Responses to Comments
Public Review of Merrimack Station
NPDES Permit No. NH0001465

U.S. Environmental Protection Agency
5 Post Office Square
Boston, Massachusetts 02109

Figure II.2. Mean and maximum daily (24-hour average) temperature (deg C) at Stations S0 (discharge) and S4 (downstream) from August 10 through September 30, 2010 compared to the juvenile alewife avoidance temperature (28.9°C).

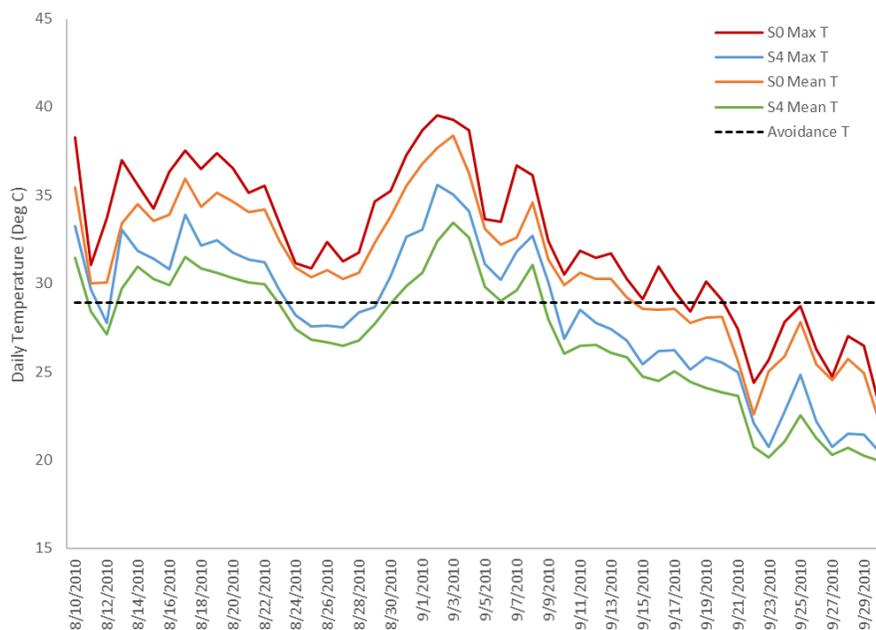
Based on the 2016 averaged data summary, LWB states that the average maximum temperature only exceeded 28.9°C on 14 days between July 16 and August 10, which is before juvenile alewife would be migrating. *See* AR-1300 p. 35, AR-1299. LWB and PSNH conclude that temperatures will be protective during the period in which alewives would be migrating past Merrimack Station. *See id.* EPA reviewed *daily* temperature data over the period from 2004 through 2018. The maximum daily temperature at Station S0 and S4 frequently exceeds 28.9°C after August 10 through early September, including as late as September 22 (at Station S4) and September 28 (at Station S0). Daily data from 2010 demonstrate that the mean daily temperature at S4 during that year was above 28.9°C from August 13 through August 22 and again from August 31 through September 9, and that the maximum daily temperature exceeded 28.9°C for nearly the entire period from August 10 through September 9 (Figure II.2, below). The daily data demonstrates that, in contrast to the LWB’s analysis and consistent with EPA’s conclusion in the 2011 Draft Determinations Document, temperatures in the river are above the protective temperature during the period when outmigrating juvenile alewife are present.

At the same time, EPA acknowledges that juvenile alewives could potentially avoid higher temperatures if the plume were sufficiently limited to allow areas of passage. The 2016 data demonstrate that the average daily temperature at Station S0 is less than the avoidance temperature of 28.9°C (84°F) on each day beginning on September 5, which indicates that river temperatures at S0 appear to be suitable for juvenile alewives by the end of the first week of September. When operating as a baseload plant, such as in 2010, the sustained, elevated temperatures could potentially exclude juvenile alewife from habitat downstream of the Merrimack Station for sustained periods, including when juveniles are outmigrating and must

travel through the lower Hooksett Pool. However, under current operations (like a peaking plant) Merrimack Station operates infrequently in August and September, and, as a result, the temperature at Station S4 is typically well below the avoidance temperature for juvenile perch. As an example, Figure II.3 presents the mean and maximum observed temperatures at Stations S0 and S4 in August and September 2016, when the capacity of the Station was, on average, 9%. Excursions of protective temperatures for juvenile alewives are limited in duration and extent. This data suggests that, under current operations, the thermal plume is unlikely to impact juvenile alewives because juveniles can avoid the plume and will not be excluded from potentially suitable habitat for extended periods of time.

Figure II.4. Mean and maximum daily (24-hour average) temperature (deg C) at Station S4 (downstream) from June 25 through September 3, 2018 compared to the acute protective temperature for juvenile American shad (29.4°C).

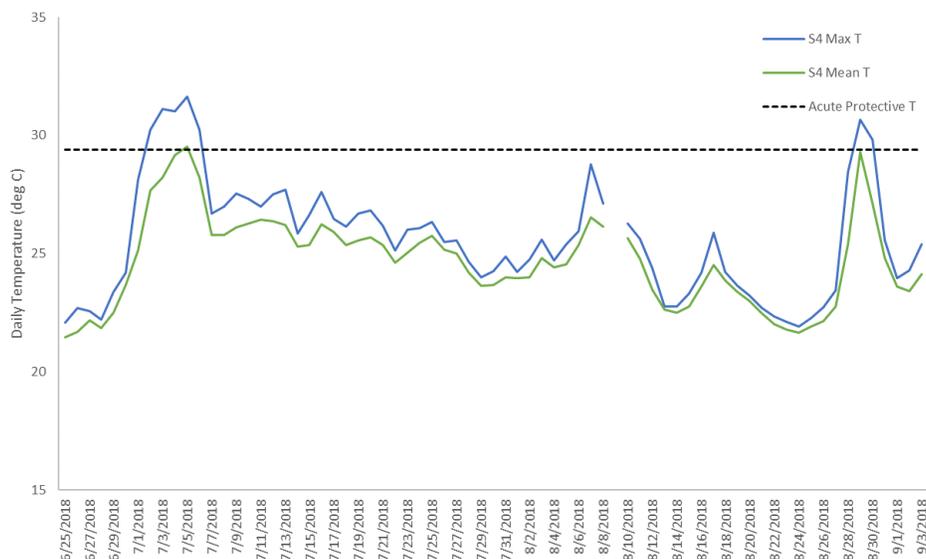
Normandeau also comments that, based on the mean average daily temperature (rather than just the maximum), Station S0 did not reach the lethal temperature identified for larval American shad (33.3°C) at all in June and only on 10 dates in July, and that the mean average daily temperature at Station S4 is well below the lethal temperature for all dates in June and July. *See* AR-872 pp. 98-9. Yet, EPA's review of daily temperature data from 2004 through 2018 indicates that the mean, maximum, and minimum S0 temperatures reach or exceed 33.3°C in July, when Merrimack Station is operating, in some cases for 25 days or more (e.g., 2004, 2007, 2010, 2011). The mean daily temperature at Station S4, however, is typically below lethal temperatures, though mean temperatures did reach or exceed 33.3°C on 8 days in 2010. In addition, the maximum S0 temperature has rarely reached 33.3°C at Station S0 since 2014, and S4 temperatures have not reached lethal temperatures since 2010.

While EPA overestimated the duration that the maximum temperature at S4 exceeded certain thresholds (due to a misunderstanding of the data), PSNH, Normandeau, and LWB, by relying only on long-term average data, plainly underestimate the severity and duration of exceedances of the protective temperature for juvenile and larval American shad due to the thermal plume during the period when they are likely present in the Merrimack River. Again, however, the potential impacts of the thermal plume on American shad have changed substantially since Merrimack Station transitioned to reduced operations like that of a peaking plant. As an example, Figure II.4 presents the mean and maximum daily temperature at Station S4 in 2018, which is representative of average operation in August and September and includes 6 dates in July when exceeded protective temperatures for larval American shad at Station S0. Under current operations, temperatures at Station S4 rarely reached or exceeded protective temperatures for juvenile American shad and exceedances that did occur were limited in duration. EPA concludes that the thermal plume under current operations is unlikely to impact juvenile American shad because juveniles are likely to avoid the plume for the limited period when it is present downstream of the discharge and will not be excluded from potentially suitable habitat for extended periods of time. EPA has also determined, in response to this and other comments received, that acute mortality is not likely to occur as a result of exposure to the thermal plume because, as just noted, American shad juveniles are mobile, will likely avoid extreme temperatures that may occur in the relatively limited segment from S0 to S4, and because under current operations it is uncommon for river temperature to exceed the acutely lethal temperature. In addition, an acute mortality limit at Station S4 will ensure that conditions in the river are protective of American shad larvae and will not result in acute mortality. *See* Response to Comment II.3.4.7.

Figure II.8. Mean and maximum daily (24-hour average) temperature (deg C) at Stations S0 (discharge) and S4 (downstream) from June 25 through September 1, 2007 compared to the avoidance temperature for juvenile and adult white sucker (29.9°C).

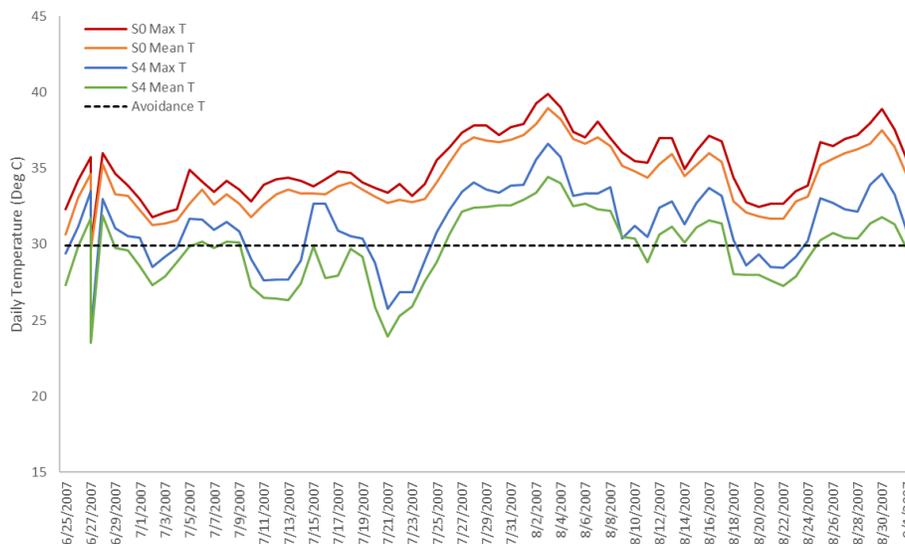
LWB points out that white sucker adults and juveniles can avoid the thermal plume, for instance, by staying upstream of the discharge where ambient temperatures are in the preferred range. According to LWB, “these fish may prefer cooler water upstream from the discharge than warmer water below the discharge, although other habitat characteristics besides temperature could explain this distribution.” AR-1300 p. 14. Electrofish sampling in 2010 and 2011 (when the Facility was operating at a relatively high capacity) supports this assertion as catch-per-unit-effort (CPUE) for white sucker north of the discharge was more than four times higher than the CPUE at stations south of the discharge. *See* AR-871, p. 42 (where Group IIB2 is represented mainly by stations in northern Hooksett Pool and IIB1 is represented mainly by stations in southern Hooksett Pool). White sucker adults and juveniles can avoid the plume, but persistent, elevated temperatures downstream of the discharge could exclude these fish from this habitat for nearly the entire summer. Under current operating conditions (*i.e.*, operating like a peaking plant from 2012 through 2018), however, the maximum daily river temperature at Station S4 reached 29.9°C on several occasions but, with the exception of July and August 2012, the duration of the event was limited (5 days or less) and the mean daily S4 temperature did not exceed 29.9°C. The change in operations of the Station since 2012 has decreased the number and duration of events when the temperature at Station S4 reaches or exceeds the white sucker avoidance temperature, which suggests that the habitat downstream the discharge would typically be available to, and protective of, white sucker juveniles and adults. There was no difference in the CPUE for white sucker in the northern and southern sections of Hooksett Pool during electrofish sampling in 2012 and 2013, when the Facility ran 5-15 days in August and September. *See* AR-1551, p. 19.

In the 2011 Draft Determinations Document, EPA concluded that maximum daily temperatures at Station S4 routinely exceeded avoidance temperatures for white sucker juveniles and adults (29.9°C) every day from June 25 to September 1, while average maximum temperatures at Station N10 remained below 29.9°C. *See* AR-618 p. 112. Correctly understood, the 2007 Normandeau report data only showed that the maximum temperature from June 25 to September 1 exceeded avoidance temperatures on each of those days in at least one year out of the 21-year data set, but did not necessarily do so on multiple days in the same year or in sequential years. According to LWB, the 2016 report presenting the average of the multi-year temperature data shows that the average daily maximum temperature at Station S4 reached 29.4°C (85°F) on only 3 dates during July, and never exceeded the avoidance temperature (29.9°C). *See* AR-1300 p. 37. *See also* AR-872 p. 112. Yet, reviewing the actual, observed daily temperatures demonstrates that the daily maximum and mean temperature at S4 routinely exceeded 29.9°C between June 25 to September 1 in 2004, 2005, 2007, 2010, and 2011, albeit not every day. Figure II.8, from 2007, supports the 2011 Draft Determinations Document's conclusion that daily maximum and, in some cases, mean S4 temperatures reach avoidance temperatures for juvenile and adult white sucker for large portions of the summer.

Figure 1: Merrimack Quarterly Heat Input, 1995-Present²¹

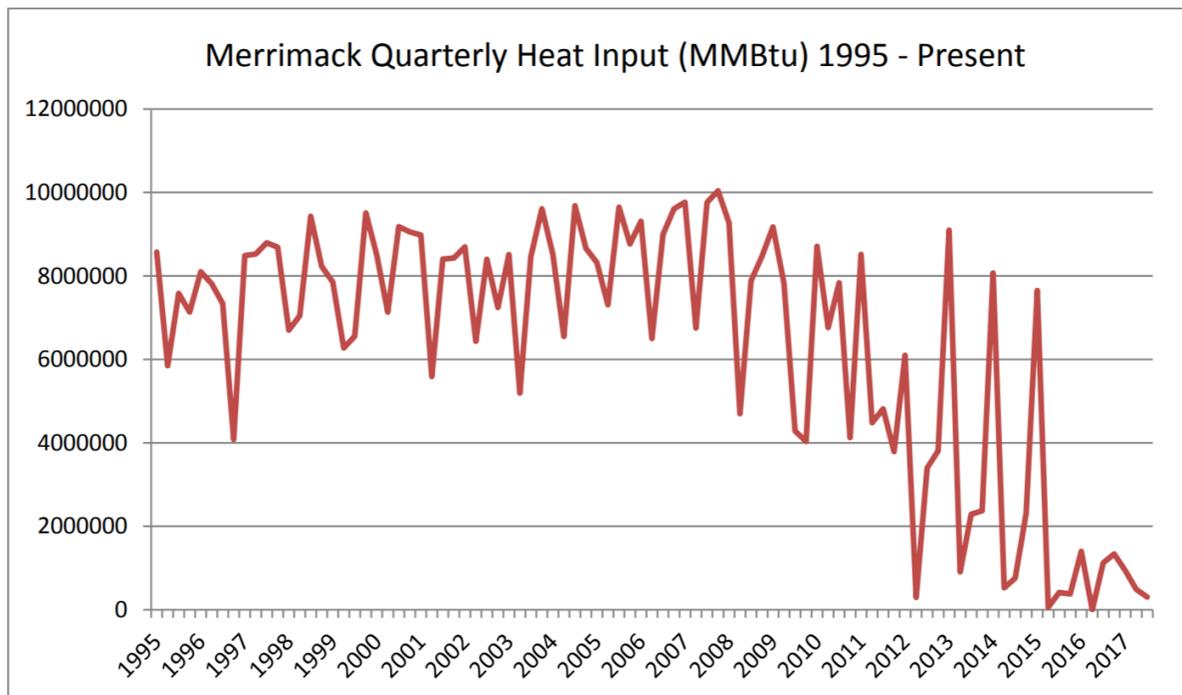
Second, as EPA implicitly recognizes, while Merrimack’s annual capacity factor may be lower in recent years than in years further back, it still operates quite heavily for short periods of time in the winter and in the summer. Setting limits based on annual output would improperly ignore Merrimack’s high level of operations, and concomitant environmental impacts, during those periods of time. This would be particularly troublesome given the seasonality of the thermal impacts described above, where it is precisely the thermal pollution Merrimack causes during the winter that provides a toehold for invasive species and threatens the balanced indigenous population of aquatic species in the Merrimack river.

Third, the unfortunate fact is that EPA is extremely slow in issuing NPDES permits for large facilities in New Hampshire, and for Merrimack in particular. These comments are submitted as part of the third round of comments solicited by EPA on this one permit, in a process that started over five years ago. Indeed, Merrimack has been operating under a permit that expired two decades ago, and was issued a quarter-century ago. Although Commenters certainly hope that EPA will finalize this permit soon, and will thereafter hew to the five-year permit review cycle mandated by Congress, the history of this permit and this plant raises the possibility that whatever permit EPA does finalize for Merrimack may govern the plant’s operation for many years to come. Just as Merrimack’s operation has changed considerably in the past, it is possible that it will vary considerably in the future.

As such, it would be both irresponsible and contrary to law for EPA to set NPDES permit limits for Merrimack based on an assumption that, because the facility currently operates at a relatively low capacity utilization, certain wastestreams and pollution levels are unlikely to be relatively high in the future and therefore need not be limited.

Figure 3-1. Trends in electrical generation by season at the Merrimack Station, 2007 - 2016.

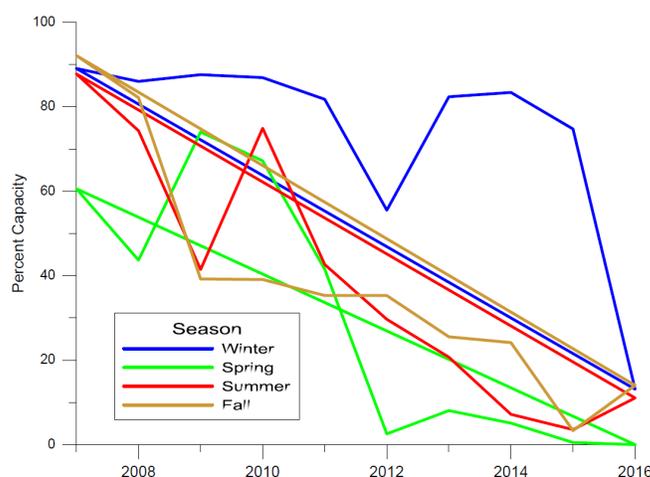
First, the potential thermal exposures should reflect likely operation of the Merrimack Station over the upcoming NPDES permit period (typically five years). As clearly demonstrated in ISO New England (2017), the Station no longer operates as a base-loaded facility as it had prior to

2010. Hence, temperature monitoring data collected prior to the draft NPDES permit (2011) does not reflect current conditions. The Merrimack Station operates principally as a peaking facility operating only when economic dispatch requires. A re-graphing of the generation data provided in ISO New England (2017) reveals a distinct seasonal pattern in operation (Figure 1). This graph clearly illustrates a substantial decline in the electrical generation at Merrimack since 2007 throughout the year except during winter. Hence, the magnitude and extent of thermal exposures to the aquatic community during most of the year are likely to be much lower than when Merrimack was operating as a baseload facility. During spring and summer, when biological productivity and potential for thermal stress is highest, Merrimack is typically operating at a capacity factor of less than 20 percent. That is only a small fraction of generating capacity of this facility prior to the 2011 draft NPDES permit. Only during winter, when natural gas availability constraints limit operation at other generating facilities is Merrimack called to run often. However, biological stresses from elevated temperatures at this time of the year should be minimal owing to low river water temperatures.

Figure - Overlay of Power Plants and Findings of *Corbicula fluminea*²⁸³

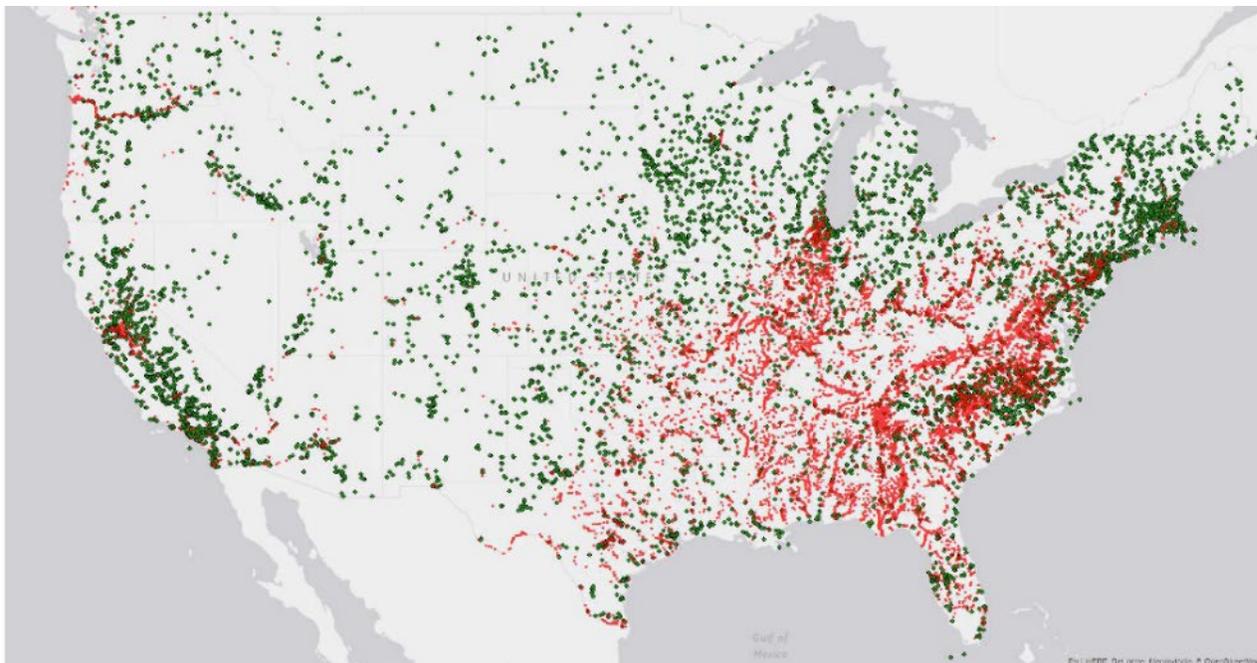
The red dots shown on the map represent Asian clam locations reported in the United States Geological Survey (USGS) database.²⁸² Further, the Asian clam is extensively found near power plants (shown in green):

Given EPA's silence concerning the Asian clam despite receiving the findings of Normandeau that Hooksett Pool hosts a healthy, BIP of fish and macroinvertebrates, PSNH did not anticipate EPA's interest in the Asian clam until learning of it by happenstance approximately three years ago. In 2014, PSNH observed EPA conducting dives, unannounced, with NHDES in the immediate vicinity of Merrimack Station. Near this same time period, EPA responded to several Freedom of Information Act ("FOIA") requests issued by PSNH concerning the Merrimack Station permit proceeding.²⁸⁴ Although EPA never mentioned its interest in the Asian clam to PSNH, its permit holder, documents contained within EPA's FOIA production made clear EPA had fixed its focus on the Asian clam, almost to the exclusion of other species. As a mounting number of documents from EPA's FOIA production focused on the Asian clam, PSNH grew concerned EPA might be considering a new basis to attempt to shore up the fatally flawed Draft Permit and its denial of PSNH's § 316(a) variance request that were based on EPA's erroneous determination that the polluted Merrimack River of the 1960s hosted a BIP and was the appropriate baseline for comparison.²⁸⁵ Indeed, documents included in one of EPA's FOIA productions revealed that, in September 2015, EPA had contemplated a dive study for the purpose of assessing the Asian clam's effect on the Hooksett Pool BIP.²⁸⁶ As explained in this "Project Plan" document, EPA sought to improve its "understanding of the power plant's influence on this invasive species" and, in turn, to "evaluate the plant's ability to meet state and federal water quality standards, and its NPDES permit requirements, as they apply to protecting the resident biological communities."²⁸⁷ Among its study objectives, EPA planned to "assess the abundance of *Corbicula* relative to native epifaunal and infaunal macroinvertebrates," in addition to "*Corbicula*'s capacity to displace native invertebrates, including mussels."²⁸⁸ However, EPA's study plan was abandoned and the evaluation was never undertaken.²⁸⁹

Figure 4-1. Percent withdrawal versus total number entrained during Merrimack River entrainment studies (2006-2007) (Normandeau 2007b).

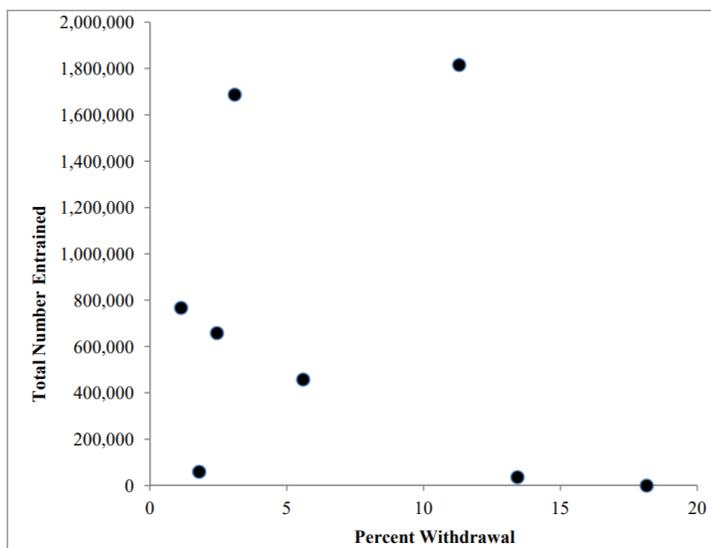
[Responding to AR-618, p. 245 Section 11.2.1a] USEPA provides no evidence for the assertion that eggs and larvae are equally distributed throughout the river. In fact, the peer-reviewed scientific literature indicates that ichthyoplankton have a very patchy spatial and temporal distribution. USEPA provides no basis for its assumption that the percent of water withdrawn for cooling can provide an estimate of the percentage of the ichthyoplankton lost to entrainment. The percentage of the water withdrawn is a factor in determining entrainment, but density of ichthyoplankton in Hooksett Pool over space and time are also important factors. Existing entrainment and withdrawal data do not support the Agency's assumption that entrainment is proportional to percent water withdrawal because the months with the greatest percentage withdrawal are also the months with the lowest ichthyoplankton densities. Figure 4-1 presents a plot of percent withdrawal on the x axis versus total entrainment on the y axis (Table 3-7; Normandeau 2007b). There is no apparent positive relationship between percent withdrawal and total monthly entrainment. In fact, a non-parametric Spearman Rank Correlation analysis indicates that there is a negative relationship (-0.41) between percent withdrawal and total monthly entrainment. The raw data are presented in Table 4-1. The months with the greatest percent withdrawal, August and September 2006, also have the lowest entrainment because ichthyoplankton are not common in Hooksett Pool during those months. The highest entrainment occurred in June of 2006 and 2007 when percent withdrawal was relatively low (June 2006), or

above average (June 2007) but entrainment was highest due to the high density of ichthyoplankton in Hooksett Pool. The conclusion to be drawn from this analysis of empirical data is that percent water withdrawal alone is not a major factor in determining entrainment at Merrimack Station. Density of ichthyoplankton in Hooksett Pool is also an important factor and the greatest percent withdrawals occur in the months when ichthyoplankton density is low. It can be seen that during May, low ichthyoplankton densities are the norm, and that the entrainment estimate for May at Unit 2 is driven by the relatively large amount of ichthyoplankton collected on the night of 31 May (Table 4-2). The data from the night of 31 May might be considered the outlier rather than the 0 counts at Unit 1, but Normandeau included all data in the analysis because there are no methodological reasons to exclude them. Empirical data should not be excluded because it appears to be “different,” but may only be excluded if there is some methodological reason that would justify the exclusion, such as abnormal field sample collection or mishap during laboratory analysis. These incidents did not occur. Therefore, USEPA’s rationale for excluding the data for Unit 1 from May, and substituting the Unit 2 data for the Unit 1 data is not valid. Normandeau’s data estimated 3.2 million larvae per year were entrained, and USEPA improperly changed this number to 3.8 million larvae entrained.
